CITY OF PUYALLUP

October 9, 2020

DEVELOPMENT REVIEW TEAM (DRT) LETTER	
PERMIT #	P-20-0085
PROJECT NAME	Andrey's Estates Prelim Plat
PERMIT TYPE	Preliminary Major Plat & SEPA
PROJECT DESCRIPTION	Proposed eight (8) lot subdivision (preliminary major plat). Project is zoned RS-06 (Urban density single-family residential zone). The RS-06 zone allows for a mix of single family, duplex and triplexes. Proposal will extend Chateau Drive and construct new roads internal to the new subdivision. Project will include grading, storm water management, utility extensions, and landscaping.
SITE ADDRESS AND PARCEL #	2617 9th St SW TPN 0419041029
ASSOCIATED LAND USE PERMIT(S)	P-20-0013 (pre-app)
APPLICATION DATE	August 21, 2020
APPLICATION COMPLETE DATE	August 26, 2020
PROJECT STATUS	Active Development Review Team (DRT) review case – resubmittal required. Please address review comments below and resubmit revised permit materials and by responding in writing to the remaining items that need to be addressed. Please see the end of this letter for a resubmittal link and further instructions.

March 11, 2020 pre-application proposed project layout:

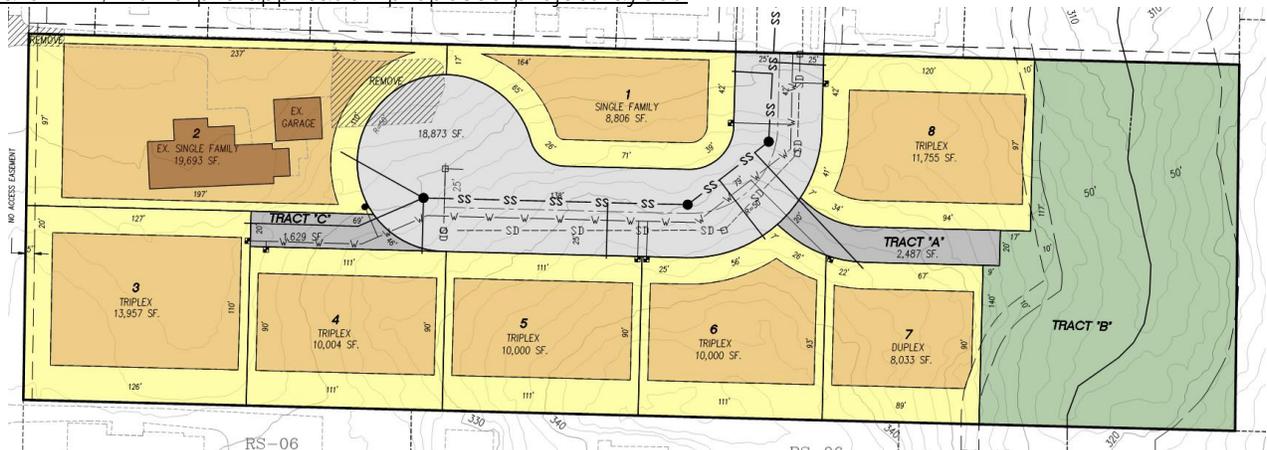
1. At the time of the pre-application meeting, the project showed the following layout. Significantly, staff assumed based on this layout and the research assumed to have been done by the applicant at that time, that full infiltration of the site was planned and that a roadway could be extended to the eastern plat boundary with minimal impacts on critical areas. It was also assumed that some additional lot(s) could be fit within the area outside of buffers, potentially, if other lots were re-organized and adjusted.

City staff requested revisions to show a roadway stubbed out to the eastern property boundary to meet PMC 19.12.050 (1) (b) ("The arrangement of streets in new development should be such that said streets extend to the boundary lines of the tract to make provision for future extension to adjacent tracts"). The original layout of the plat appeared to assume full infiltration of storm water as no storm water facilities were shown and staff assumed the applicant's proposed storm water plan had enough information to conclude that no storm pond would be needed on the eastern basin of the site.

August 21, 2020 prelim plat application proposed project layout:

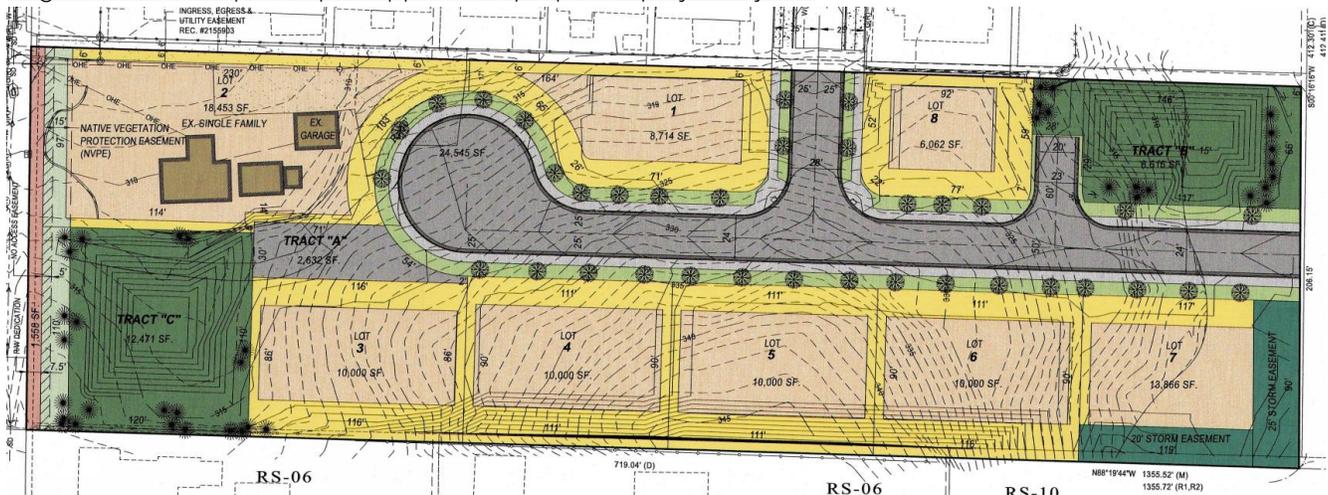
The present layout shows the roadway extended, as required, with a storm pond to the north of the extended roadway, a culverted stream through the entire site and another lot south of the roadway extension within the entire buffer area.

4. At this time, after a site visit to examine the stream corridor, vegetation and proposed preliminary plat / grading / storm water plans, staff requires the following revisions occur:

- a. Remove lot #7 and tract B from the buffer area, retain the stream in its natural drainage course, except where a roadway extends through the native stream buffer tract. Also, see density calcs below under note #5.

- b. Show roadway extended through the buffer in the reduced width staff indicated would be acceptable through the critical area. Minimize the buffer area impacts.

- c. Adjustments to the storm water pond may impact lot #8 (Planning staff assumes from discussions with Fire Protection that the turn around shown may not be needed if the eastern edge of lot #6 is 150' or less from the intersection)

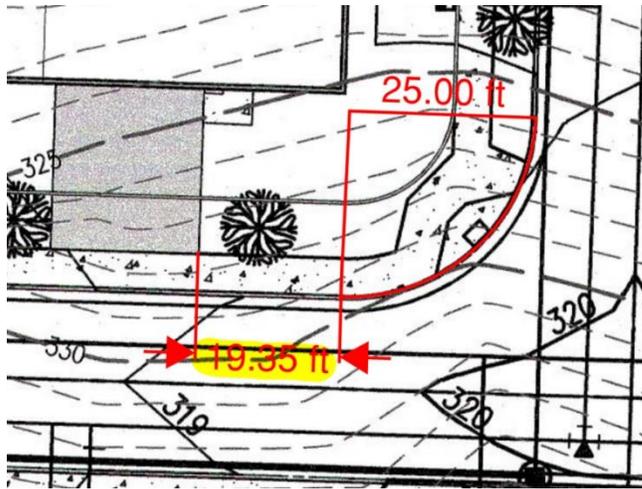
1. The current routing of the storm culvert around lot 7 is not supported by the city. The project shall only culvert the stream beneath the right of way. The proposed culvert shall be a straight run without any bends. Planning's notes require the drainage course to remain as is except where the new roadway extends through the buffer where the culvert is expected to be minimal.
2. TP#6 found ground water at approximately 311'. The ground water will may reduce the capacity of the storm pond. How will the groundwater be mitigated?
3. The submittal that was received appears very preliminary. Provide all of the submittal items outline in the application.
4. Provide utility invert and rim information for all gravity utilities.
